Appl. No. : 09/727,424
Filed : December 1, 2000

REMARKS

APPARATUS FOR OPTIMIZING CONTROL SYSTEM OF UNIT
DEVICE INTEGRATED IN MACHINE ASSEMBLY

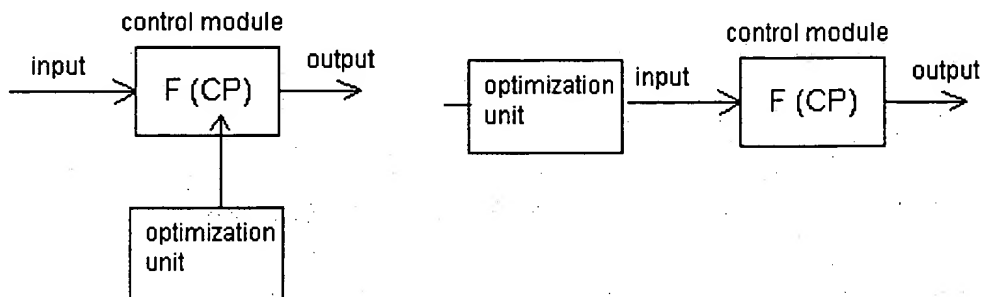
Claim 12 has been amended to further recite a basic control module in addition to the auxiliary control module arranged in parallel to or in a series with the basic control module (Figures 1b and 1c). In Lee, the Examiner thinks that the phase controller 18 is an auxiliary control module and the motor driving means 16 is a basic control module (because the auxiliary control module is subjected to optimization). However, as recited in Claim 11, the auxiliary control module is

regulated by control parameters, and the optimization process is applied to select the control parameters. In contrast, in Lee, a “control signal” (not control parameters) itself is outputted to the phase controller 18. Applying the optimization process to select control parameters (CP) is very different from applying the optimization process to output a control signal. See below.

Fig. 1e

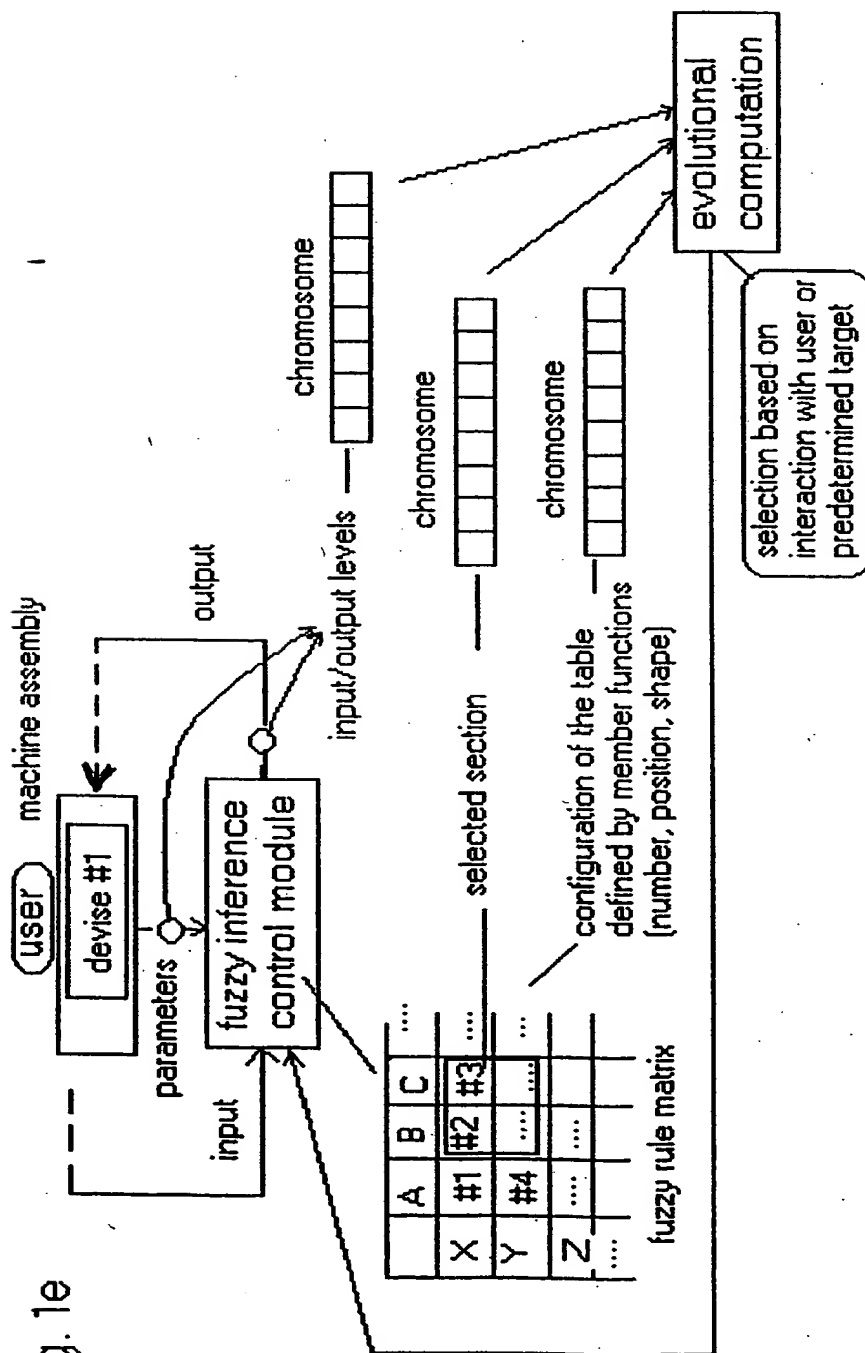
vii. The Examiner asserts that lines 24-26 of page 20 do not show any distinction between the autonomous evaluation and the interactive evaluation. The Examiner's assertion is not clear to Applicant. Figure 1e shows three ways to modify the matrix of fuzzy rules: (i) changing the membership functions, (ii) changing the fuzzy rules, and (iii) changing the input-output level (standardized coefficients) of the matrix (page 6). These are all parameters to regulate the matrix of fuzzy rules. The fuzzy rules can be expressed by numerals (e.g., Figure 7) and treated as parameters, as with the membership functions and the input-output level. In the above, (i) and (ii) may be suitably conducted by autonomous evaluation, whereas (iii) may be suitably conducted by interactive evaluation because it is preferable and easy for a user to evaluate the overall performance of the machine by judging the output of the control module (interactive evaluation). (i) and (ii) may require more complicated processing, and thus, it is more suitable to proceed autonomously, based on preselected target values. That is an embodiment explained in lines 24-26 of page 20. Applicant does not clearly understand the Examiner's assertion and believes that the sentence is not unclear.

FIG. 4

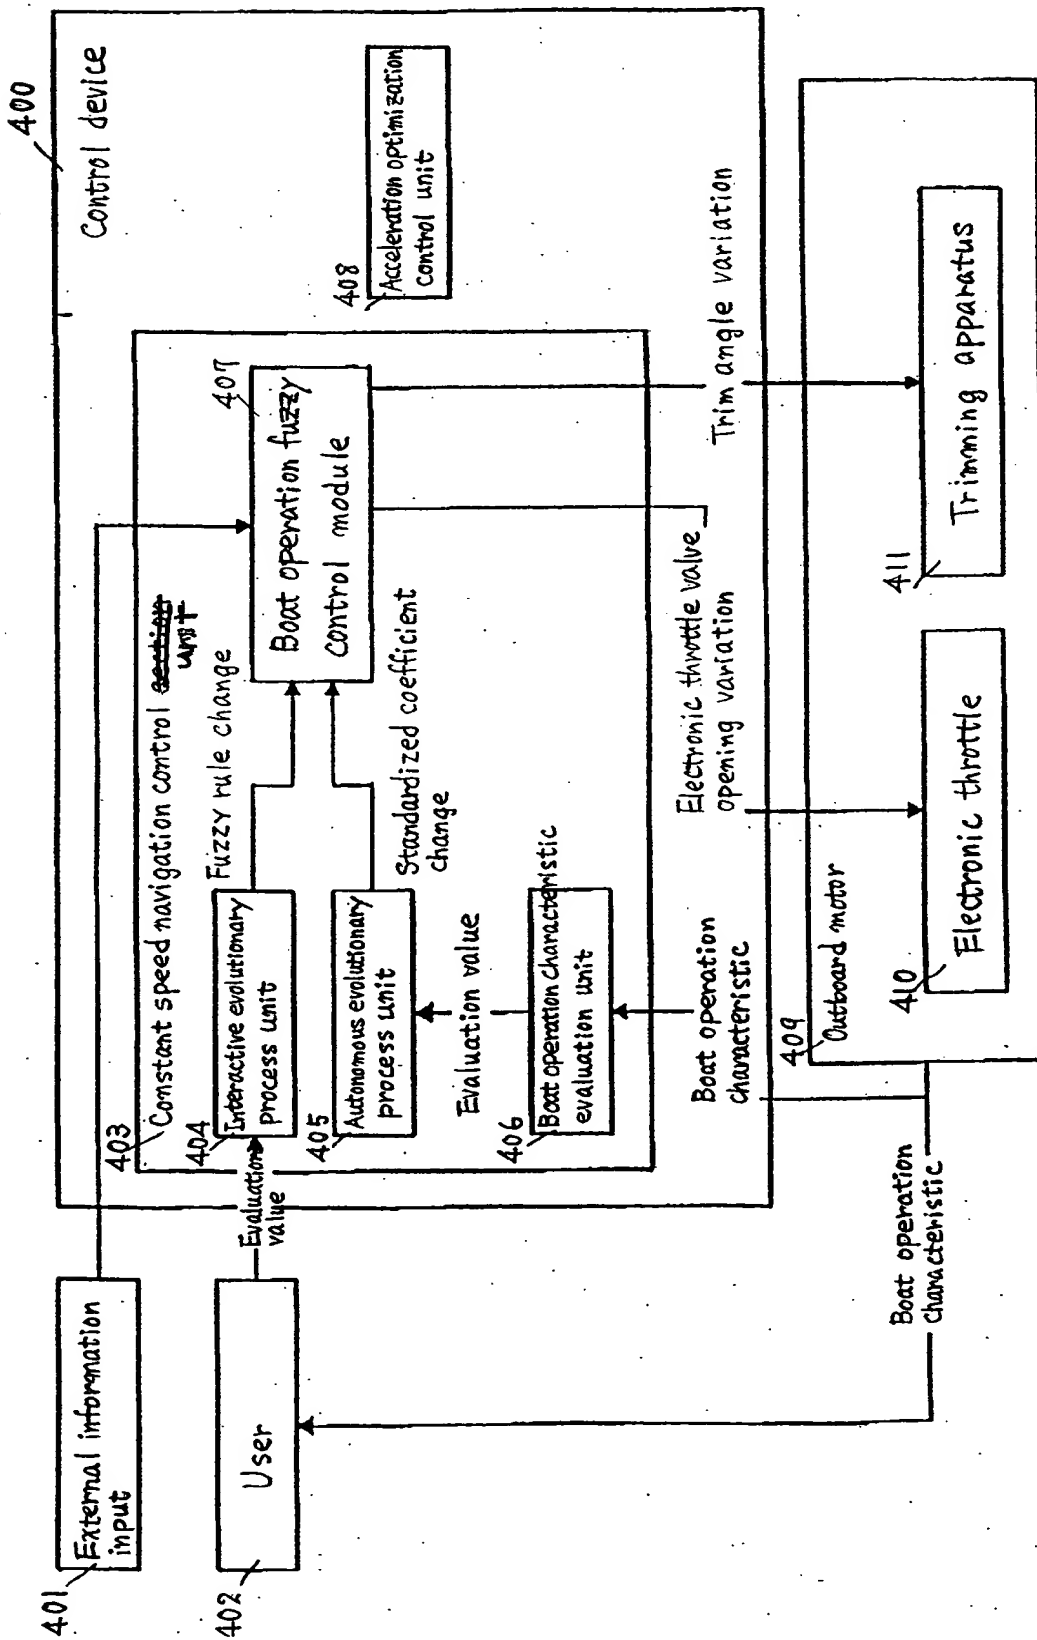
However, Figure 5 is a drawing for explaining an acceleration optimization control unit 408 (previously 504) (page 10, lines 8-17), whereas Figure 4 is a drawing for explaining a constant speed navigation control unit 403 (page 9, line 28-page 10, line 7). As explained in the section "Control in Acceleration Optimization Control Section" on page 14, line 23 through page 17, line 19, the acceleration optimization control unit does not include the fuzzy control module (Figure 14). For the Examiner's reference, the description from page 10, line 20 through page 17, line 19 can be summarized as follows:

ii. The Examiner asserts that Figure 5 fails to show a throttle control element. However, as explained above, Figure 5 is a drawing for explaining the acceleration optimization control unit 408 which does not control the electronic throttle, whereas the constant speed navigation control unit 403 indicated in Figure 4 controls the electronic throttle. Thus, Figure 5 need not show a throttle control element.

Claims 14-17 have been rejected under 35 U.S.C. § 112, second paragraph, with regard to the phrase “carries out optimization” in Claims 14 and 15. Claim 14 has been amended to clarify the autonomous evaluation unit (e.g., Figure 4 (406) and Figure 5 (507)). Claim 15 has also been amended to clarify the evaluation input unit (e.g., Figure 10).

FIG. 5

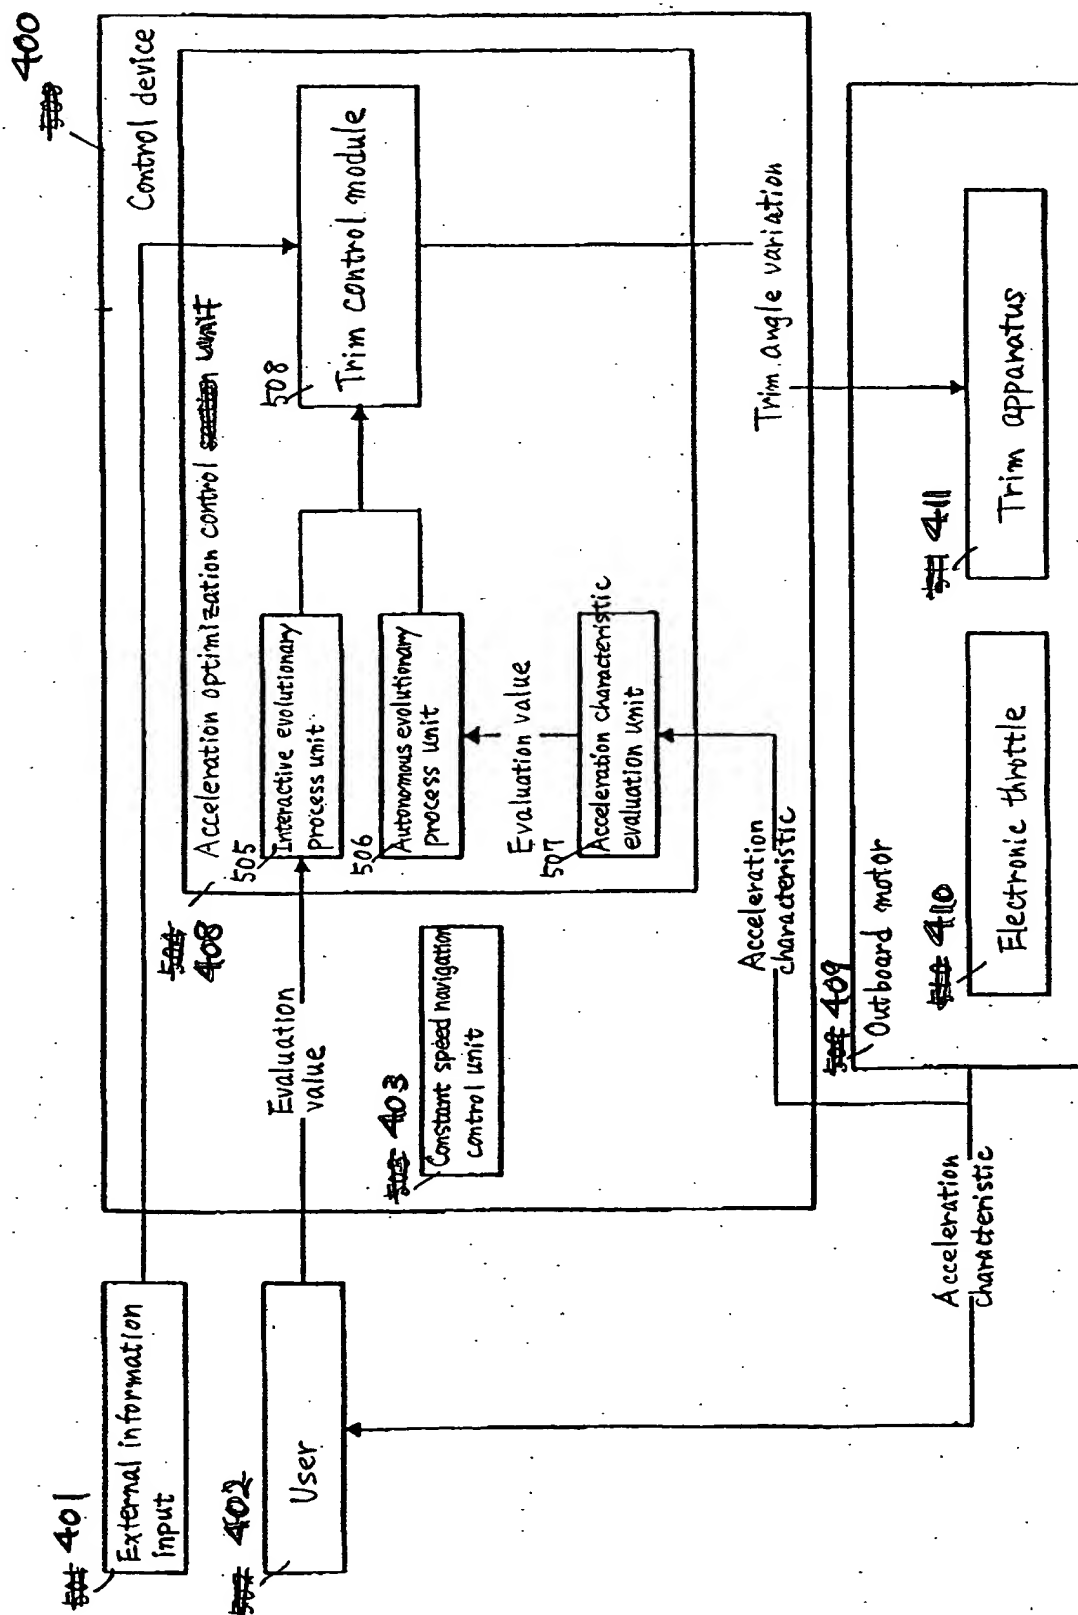
i. The Examiner asserts that Figures 5 and 6 fail to show the relationship between the fuzzy control module and the autonomous evolutionary process unit as described in the specification on page 11, lines 3-6.

Figure 6 shows a boat operation fuzzy control module 407 (previously 60) which is included in the constant speed navigation control unit 403 in Figure 4 (page 10, line 27-page 11, line 14). Thus, contrary to the Examiner's assertion, Figure 5 should not show the fuzzy control module.

iii. The Examiner asserts that the figures fail to clearly show the relationship between the total table and the fuzzy table. However, as explained above, Figure 5 is not a drawing for explaining the fuzzy control. Figure 6 shows the boat operation fuzzy control module 407 wherein inputs from the interactive evolutionary process unit 404 and the autonomous evolutionary process unit 405 are omitted simply to show the input-output relationship. The functions of the boat operation fuzzy control module, the interactive evolutionary process unit, and the autonomous evolutionary process unit are explained in Figure 8, and the total table is explained in Figure 11. Thus, Figures 5 and 6 need not show the relationship between the total table and the fuzzy table.

FIG. 10

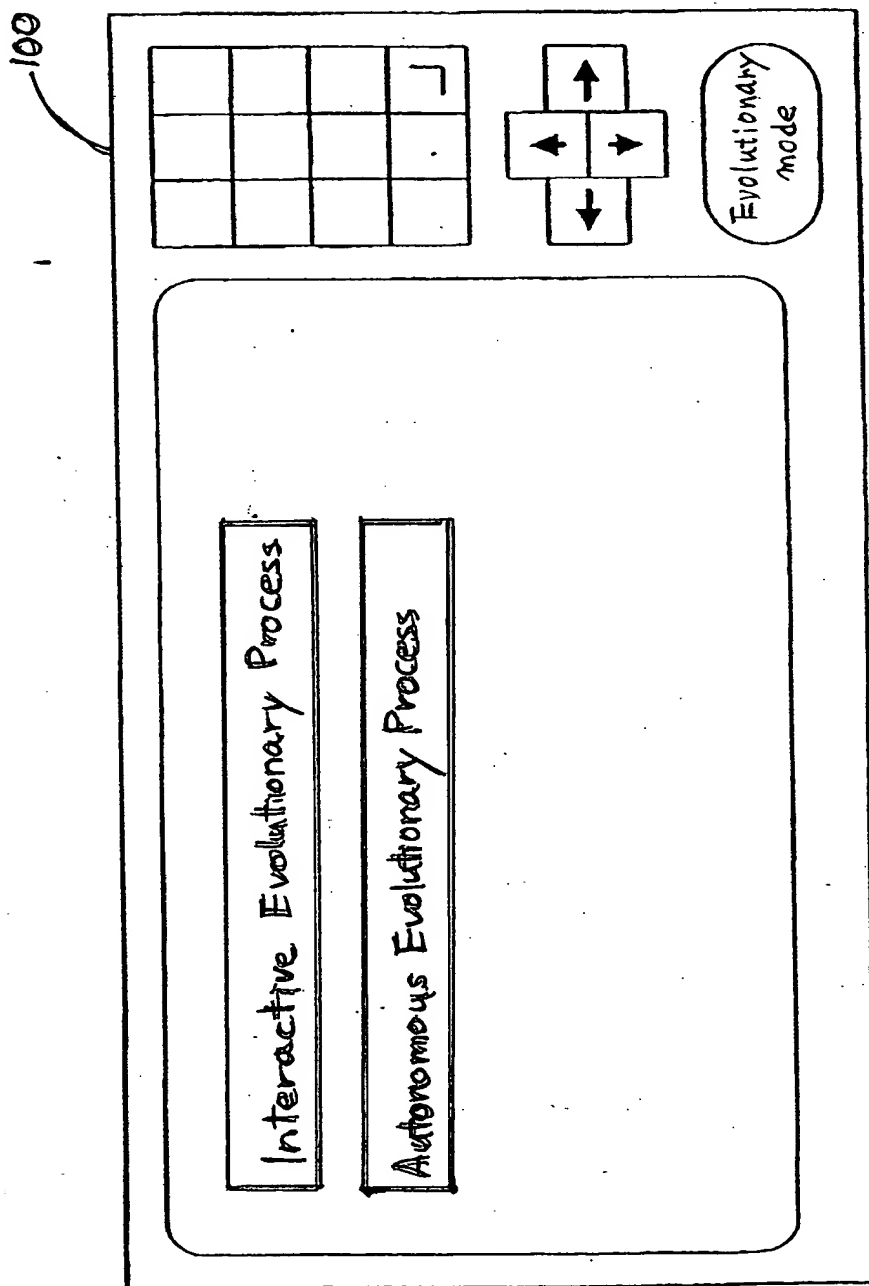
iv. The Examiner asserts that Figures 8 and 10 do not show a method for switching between autonomous evolution and interactive evolution. Figures 8 and 10 have been corrected in light of the Examiner's assertion.
